**SOIL MANAGEMENT PLAN  
AND RESPONSE TO RIVERSIDE COUNTY  
DEPARTMENT OF ENVIRONMENTAL HEALTH COMMENTS  
LOT 39 OF TRACT 7240, ±10.01-ACRE SITE  
APN 290-190-083, PROPOSED GLEN IVY SENIOR COMMUNITY  
AND RETAIL/COMMERCIAL PROJECT, TEMESCAL VALLEY AREA  
RIVERSIDE COUNTY, CALIFORNIA 92883  
CUP200011: PHASE I REVIEW**

Subject: Soil Management Plan and Response to Riverside County Department of Environmental Health Comments, Lot 39 of Tract 7240, ±10.01-Acre Site, APN 290-190-083, Proposed Glen Ivy Senior Community and Retail/Commercial Project, Temescal Valley Area, Riverside County, California 92883, CUP200011: Phase I Review

Plate 1

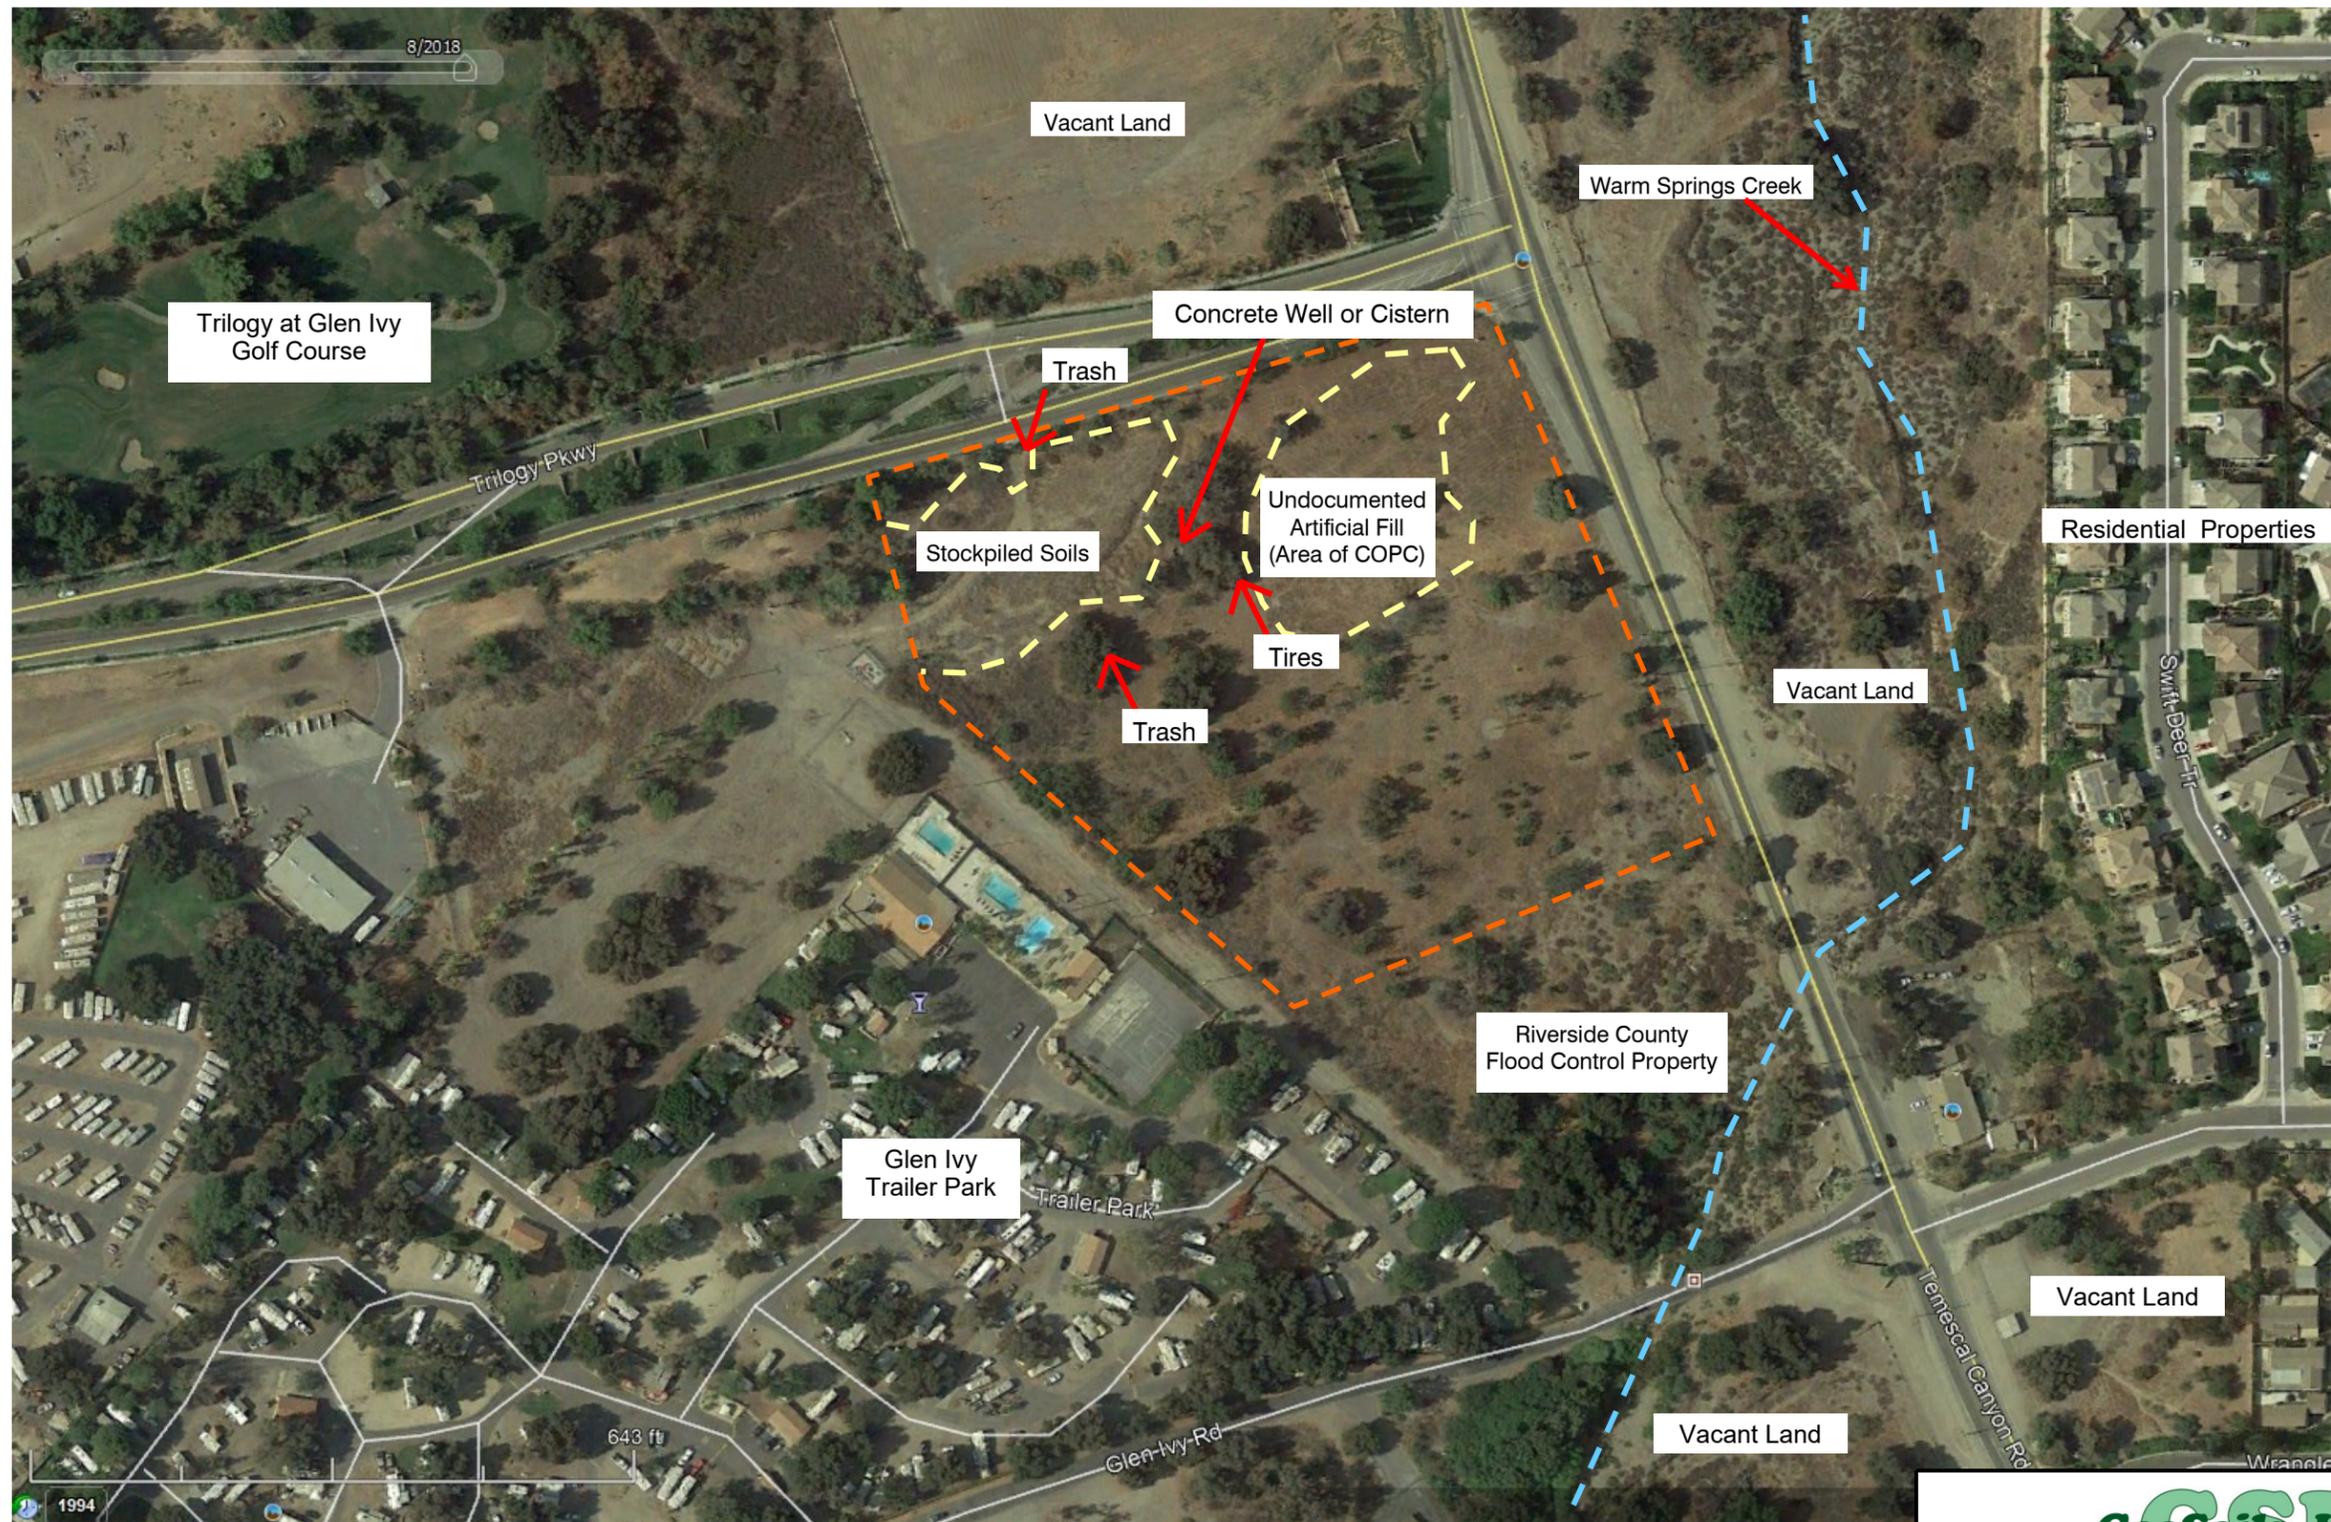
As indicated in GSI (2020c), an old concrete water well or cistern is present in the northwest portion of the site. As requested by the CRDEH (2021), the approximate location of the old concrete water well or cistern that is present in the northwest portion of the site is presented on Plate 1. Removal of the structure will be conducted under the guidance of GSI. Although not anticipated, if any other structures such as vaults, hoists, sumps, clarifiers, etc. are encountered during earthwork construction, the structure should be evaluated by GSI to determine whether residual chemicals are present based on visual/olfactory observation, or measurements taken with a hand-held PID. If field observations and/or PID readings indicate that chemicals are or may have been present within the structure, the contents should be sampled and the structure inspected for cracks/holes. If there is evidence of a release of the structure's contents to surrounding soils, additional environmental assessment may be necessary.
